Planning Commission Staff Report

Description: **Terra Corporate Park, Lot 7 (Scooter’s Coffee) SDSP:** Site Development Section Plan, Landscape Plan, Lighting Plan and Amended Architectural Elevations for a drive-up coffee shop located on a 0.84-acre tract of land located west of Trade Center Blvd. and north of Chesterfield Airport Road, zoned “PI” Planned Industrial.

RE: City of Chesterfield, MO – Code Comment Response for 16006 Manchester Road (Scooter's Coffee)

The following responses are in regard to the City of Chesterfield, MO Code Comments received on 2/16/22.

PROPOSED SITE PLAN
 701 TRADE CENTER BLVD
 CHESTERFIELD, MISSOURI 63005
 GOOD GROUNDS PROPERTIES, LLC
 8749 AKINSVILLE ROAD
 FORTUNA, MISSOURI 65034

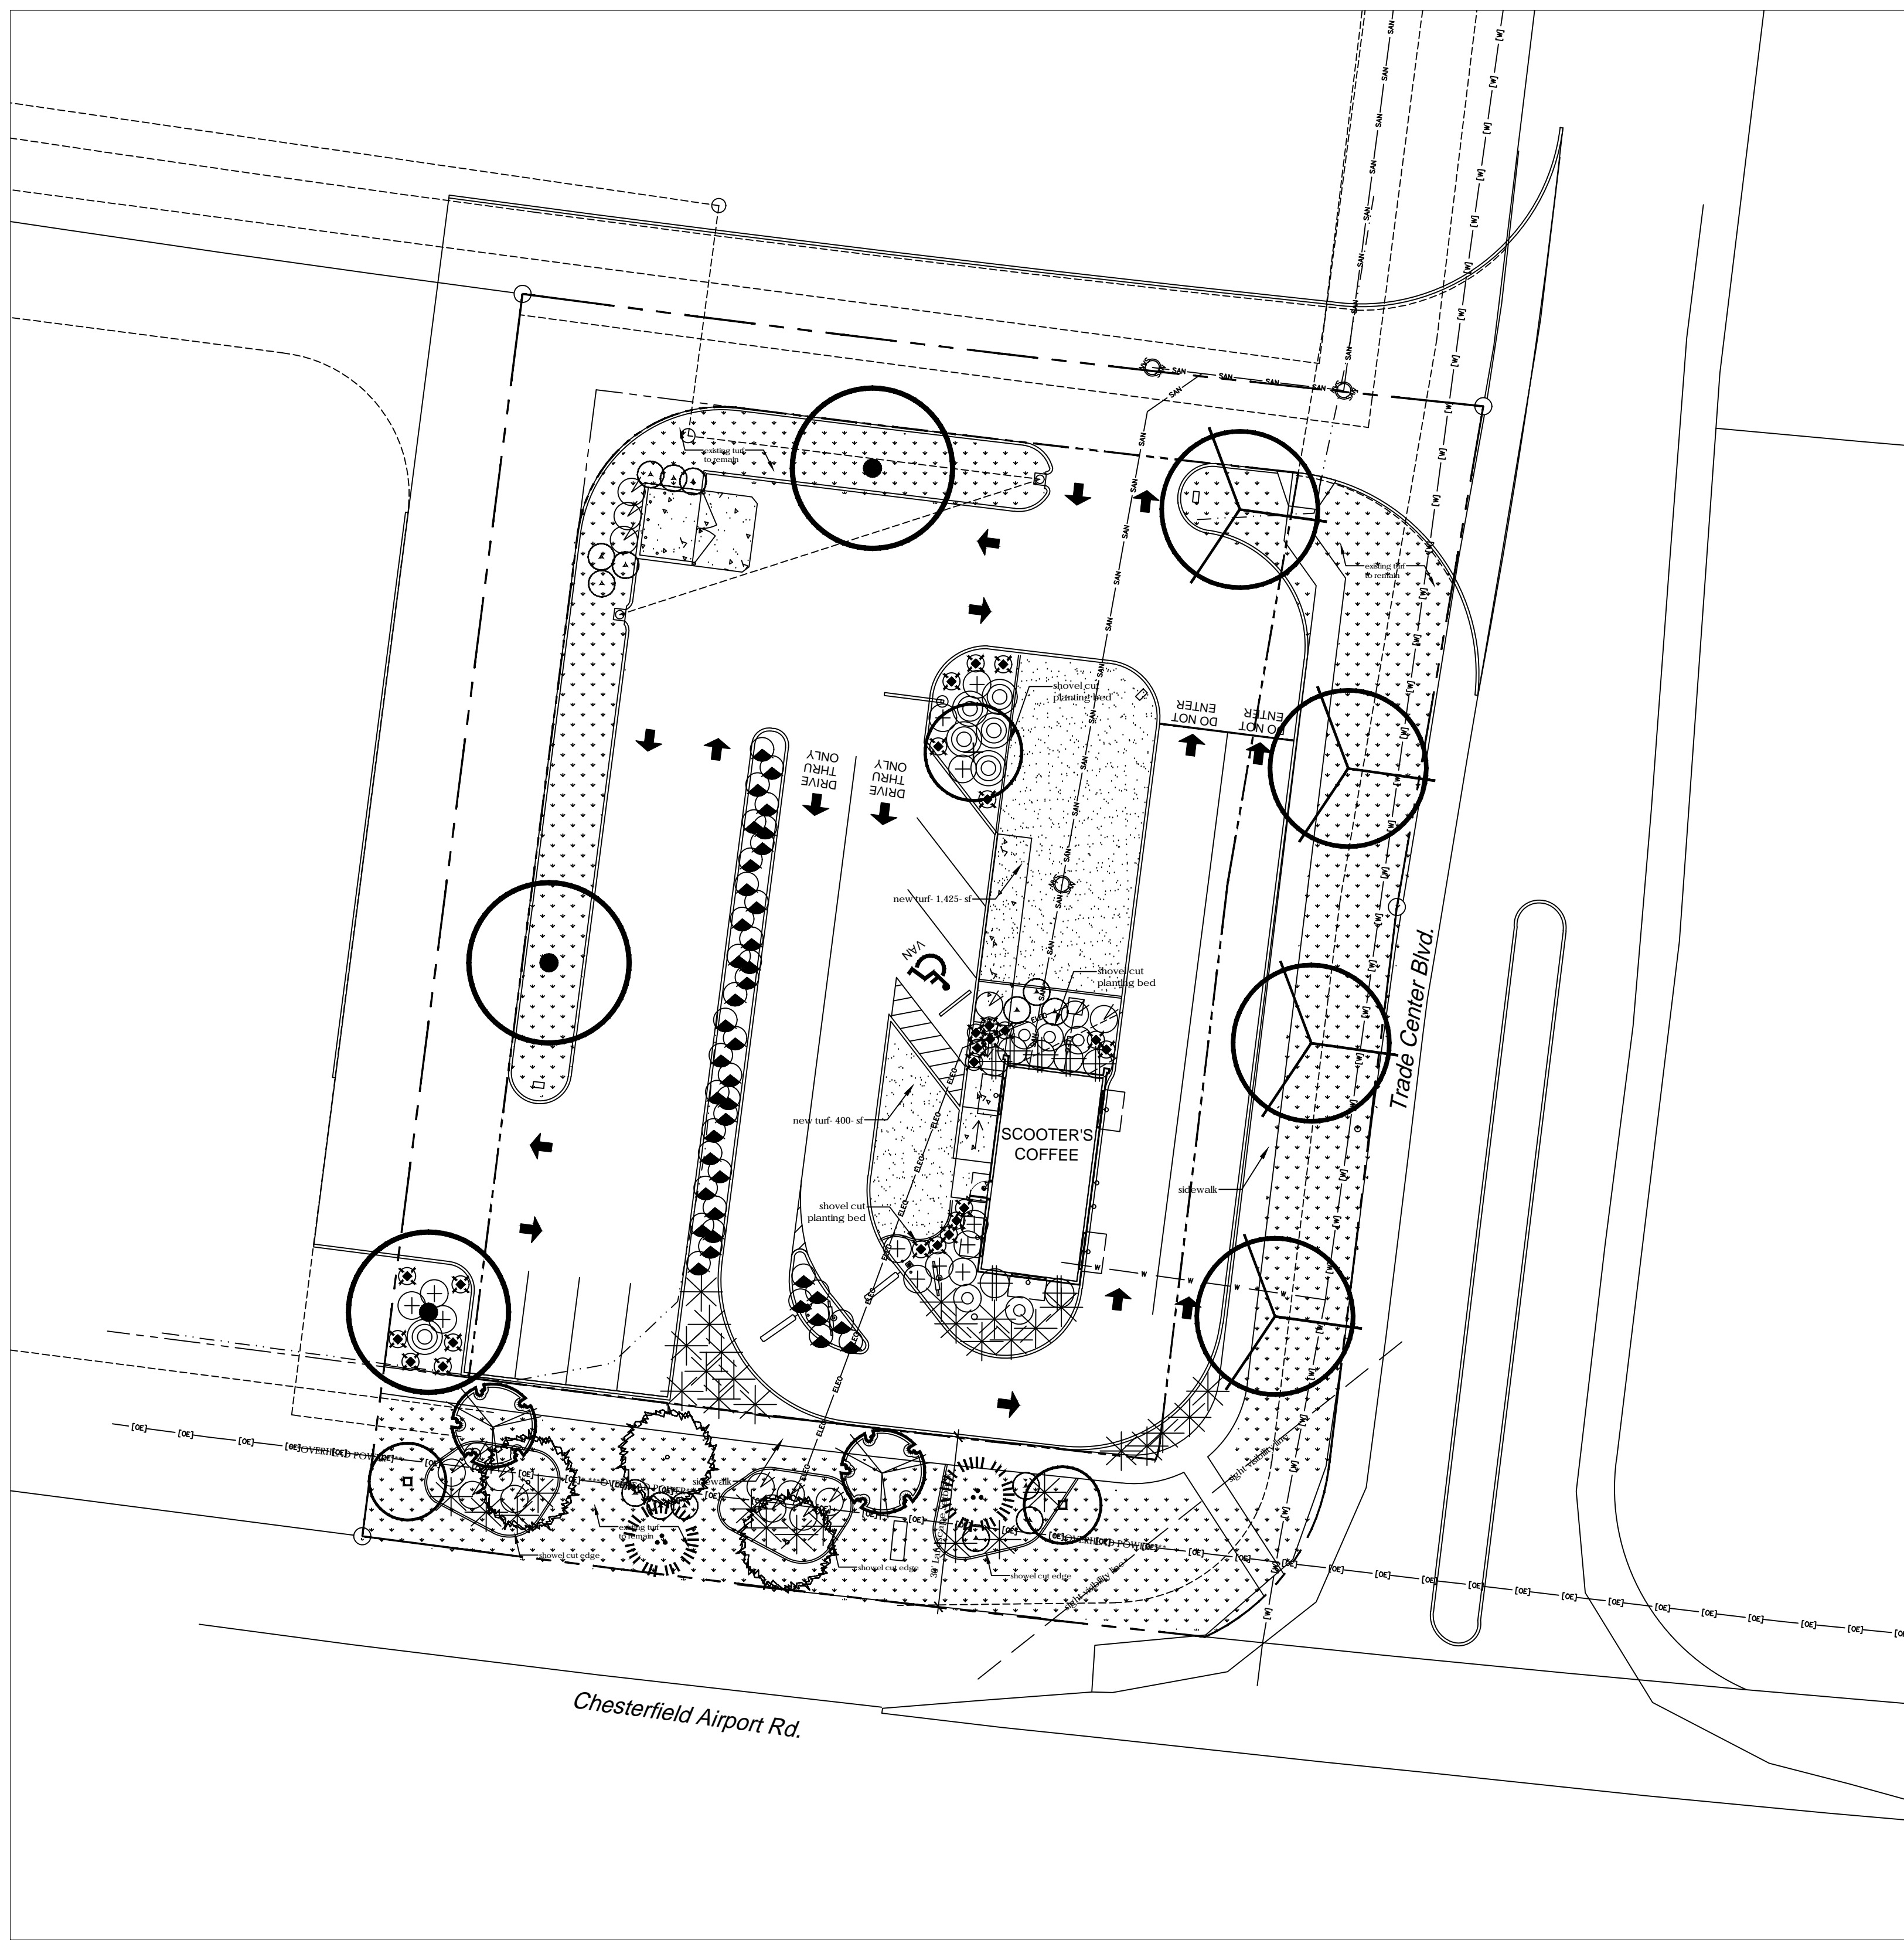
2. **Comment:** Please show the street light location on the site plan.

4. **Comment:** The location of the access points to the internal drives have been revised to match the approved Amended Site Development Concept Plan (ASDCP), as requested in the previous comment letter. However, the plans were not updated to show construction of the associated portions of the north and west internal drives between the access points. Please update the plans to show construction of the internal drives and related improvements north and west of the property to provide internal circulation to the two access points.

5. **Comment:** Provide a street light along the Chesterfield Airport Road frontage.

Response: A street light has been added along the Trade Center Blvd frontage. See Sheet C1.0 Proposed Site Plan and the electrical plans.

Response: Internal drives between the access points has been show. See Sheet C1.0.

Response: See Sheet C1.0 Proposed Site Plan and the electrical plans.

LANDSCAPE PLAN

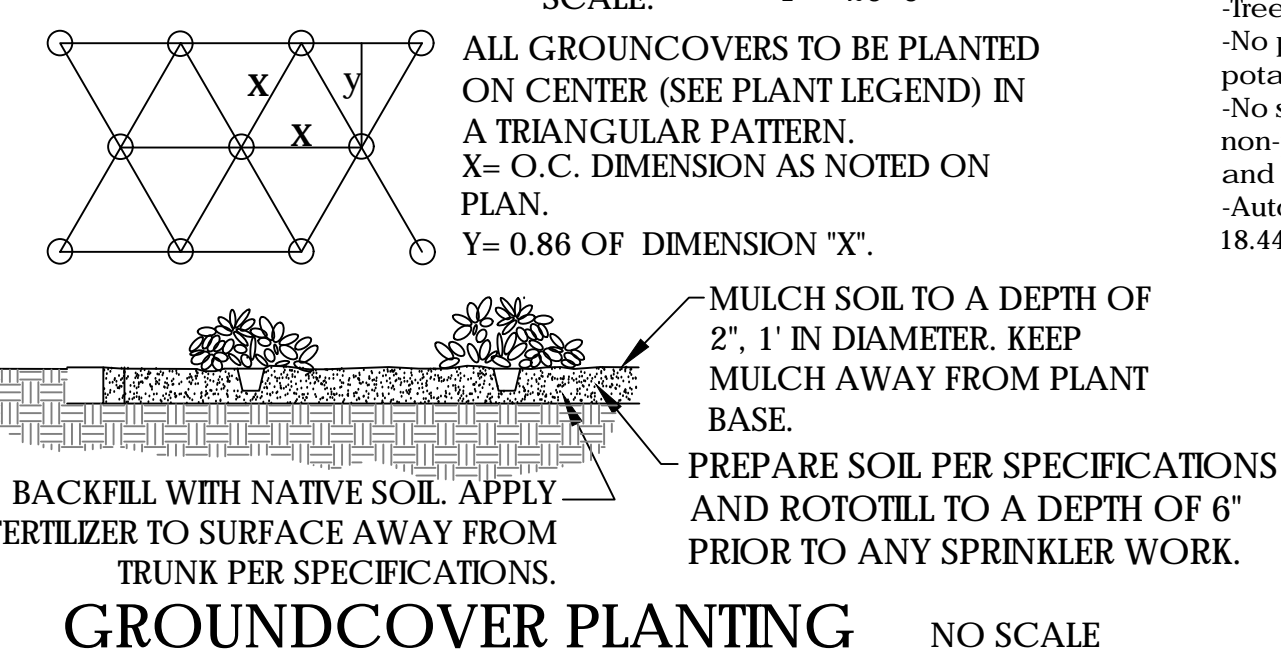
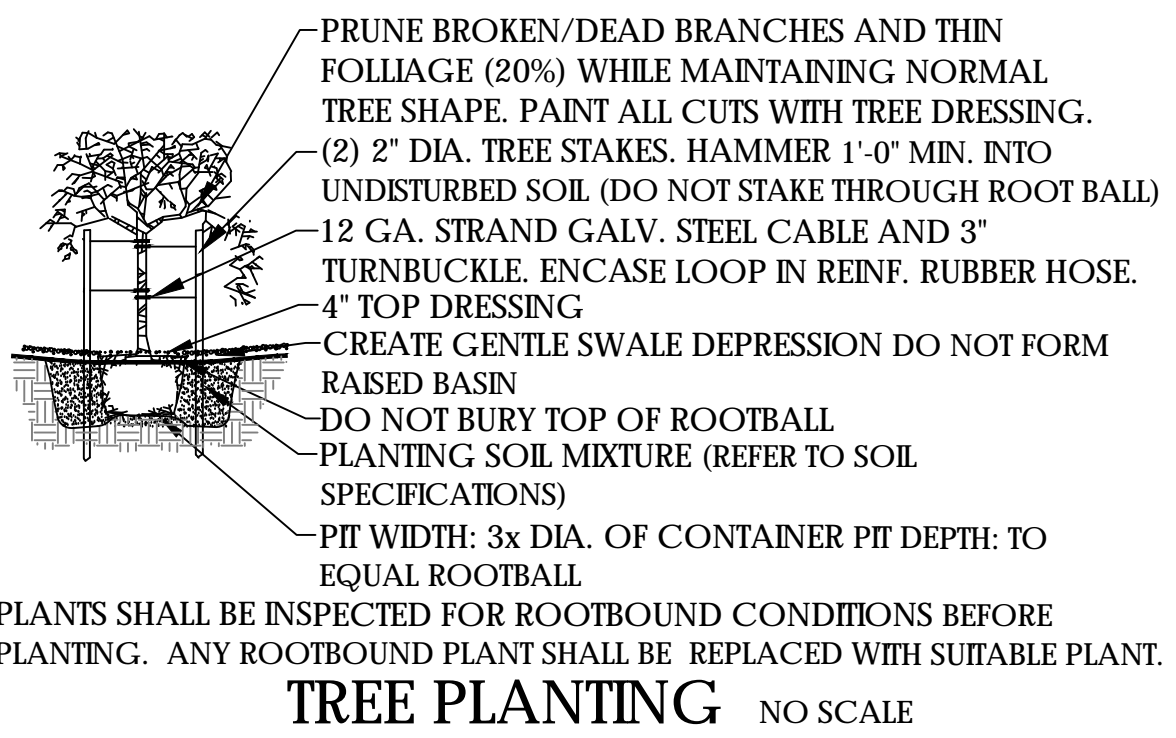
8. **Comment:** Per City code section 405.04.020 Table 2, "30' landscape buffer strip shall be provided on the site facing arterial road", please provide a 30' landscape buffer along Chesterfield Airport Road. Please refer to City Code Section 405.04.020, J for Plant selections. Provide mixture of deciduous trees, evergreen trees, and shrubs.

12. **Comment:** Additional landscaping shall be provided to screen the view of the transformer on the southern boundary.

13. **Comment:** Additional landscaping shall be incorporated around the trash enclosure to properly screen and soften the edge of the site.

15. **Comment:** Further consideration shall be made to remove or relocate the tree (River Birch) at the northwest corner of the building so that it is not too close to the building structure and has room to mature.

Response: See Landscape Plan.

Response: Additional shrubs were added around the sides of the transformer.

Response: Additional 6' tall shrubs were added around the 3 sides of the trash enclosure.

Response: The tree adjacent to the building was removed.

1 PHOTOMETRIC SITE PLAN
SCALE: 1"= 10'-0"

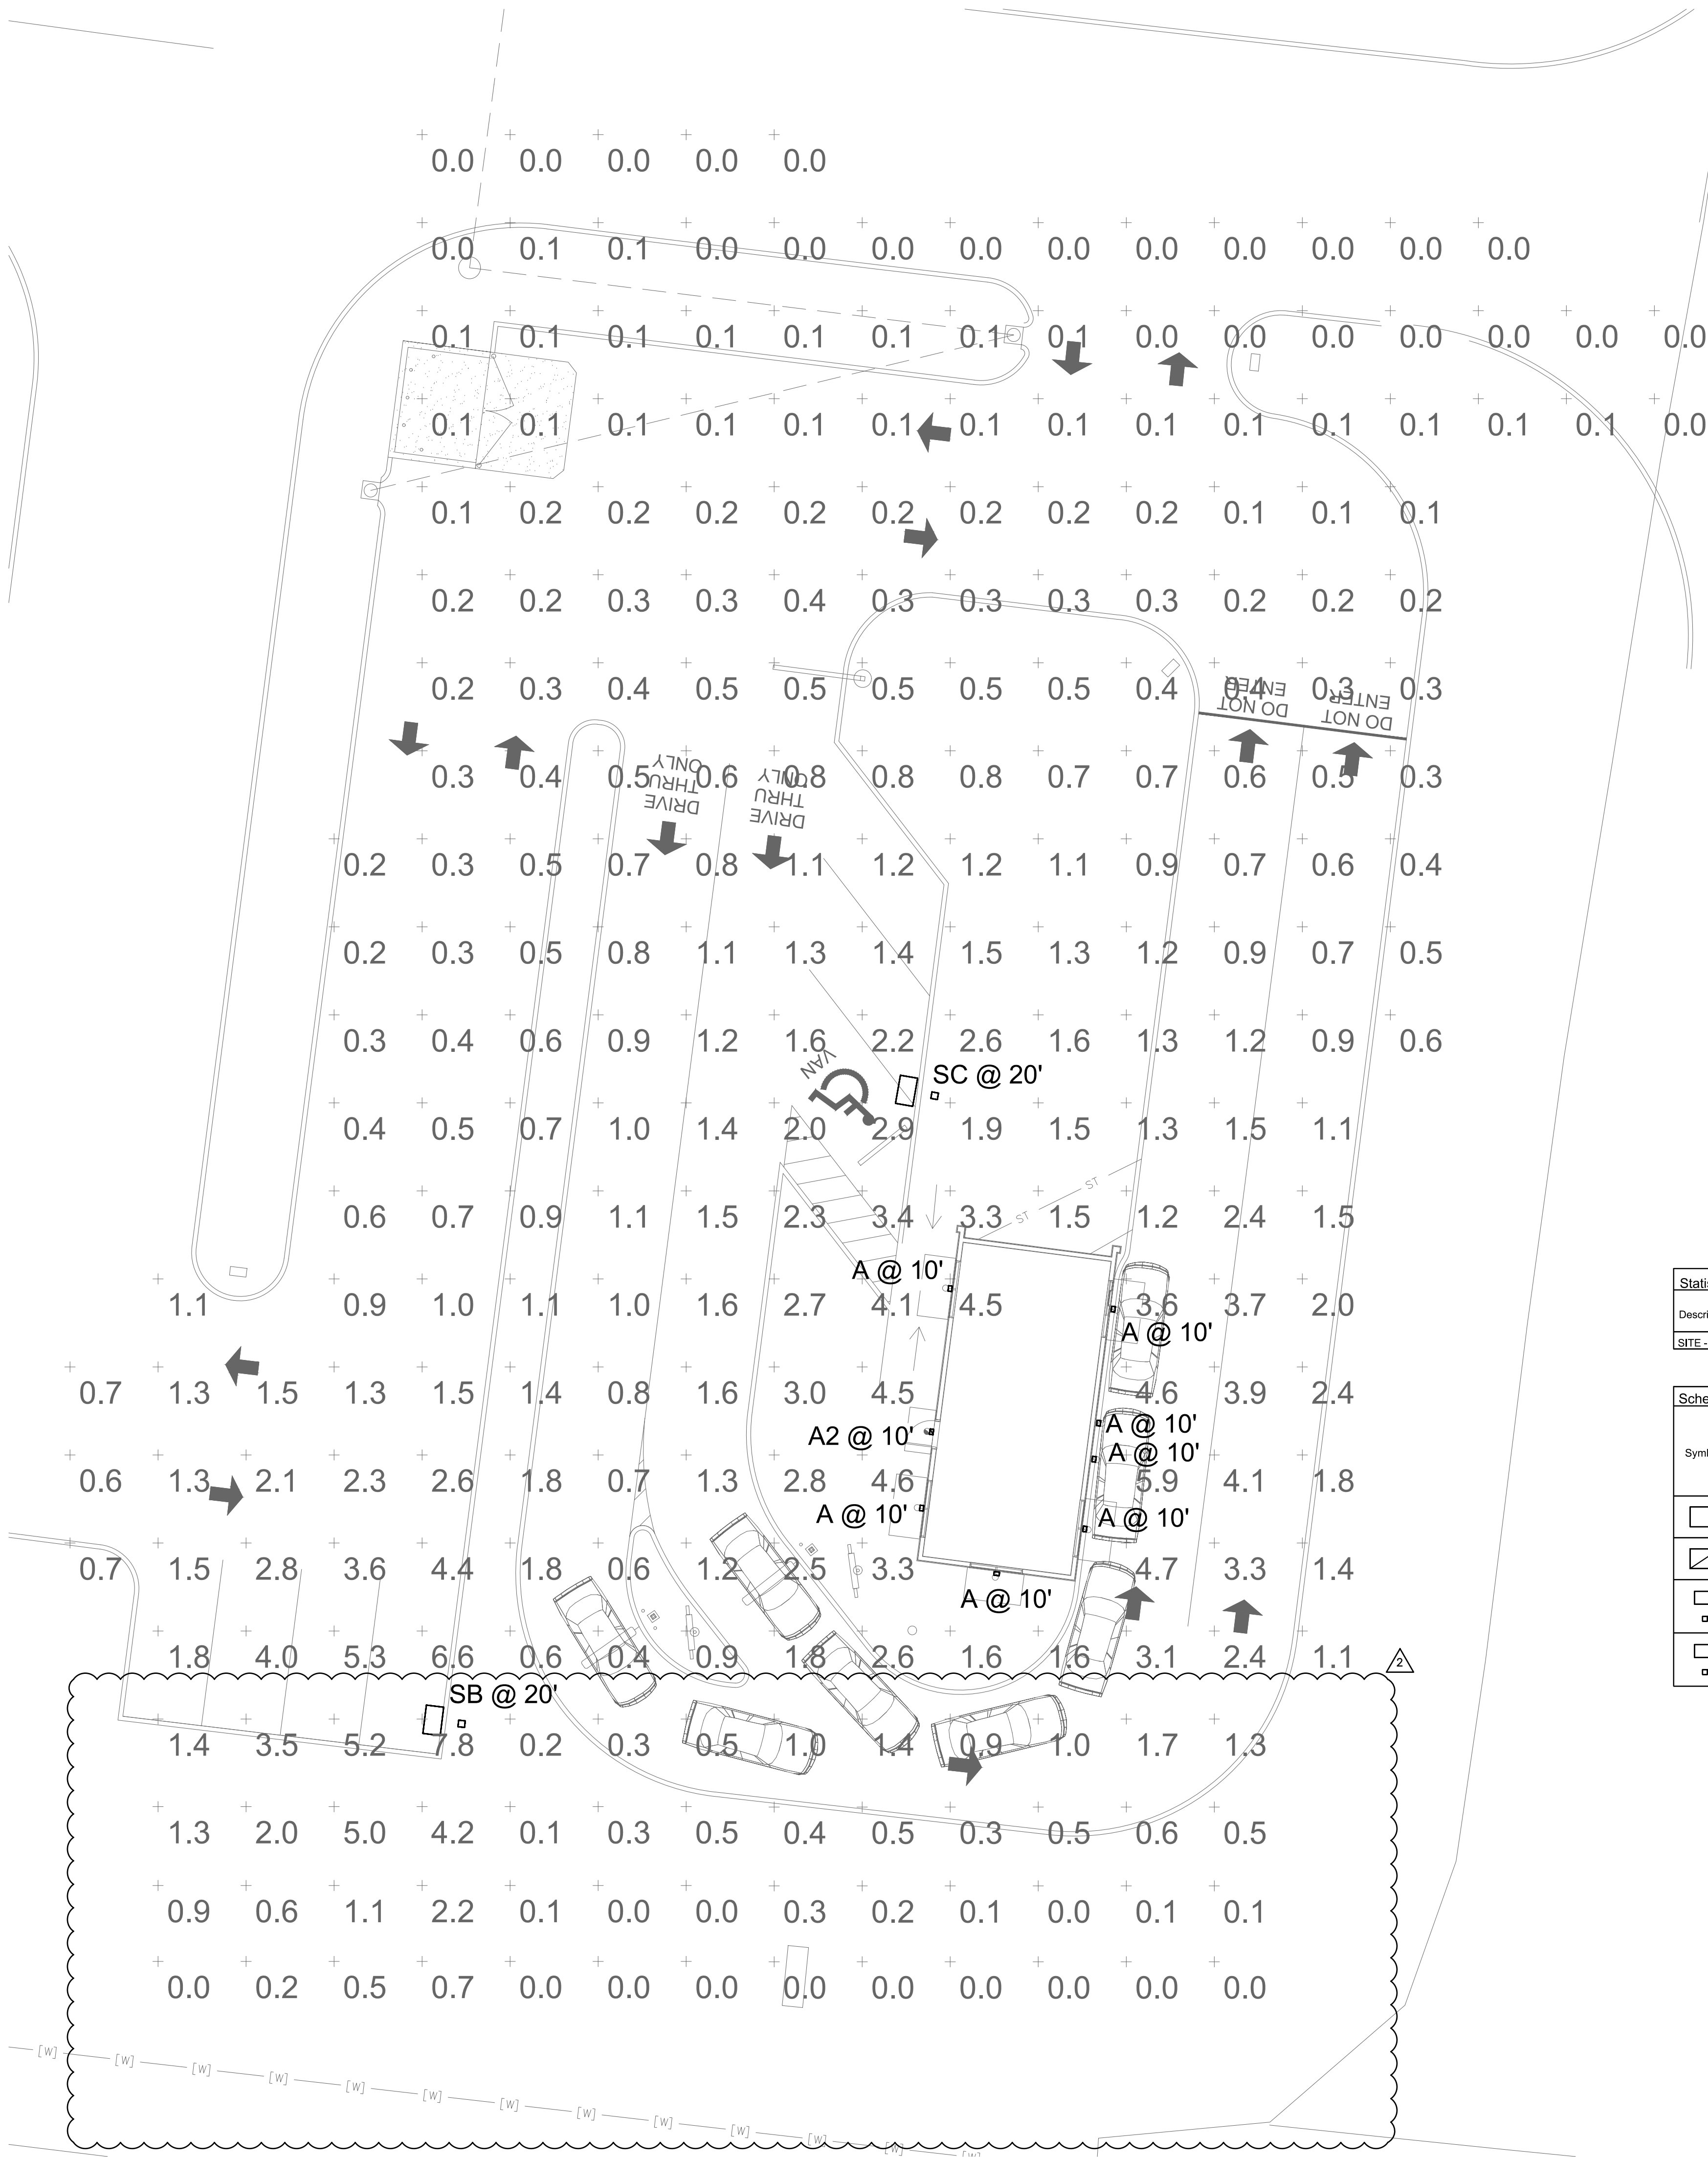
9. **Comment:** The Photometric Plan shows the light level for "SB" as 7.8 fc on the south end of the property, either provide a Photometric Plan showing the light level will be 0.0 fc on the boundary or have a note on the plan that there will be no spill over.

14. **Comment:** The light levels along the southern boundary shall preclude any spillover light on adjacent properties throughout the review of the site plan.

Response: See Electrical Plans.

Response: See Electrical Plans.
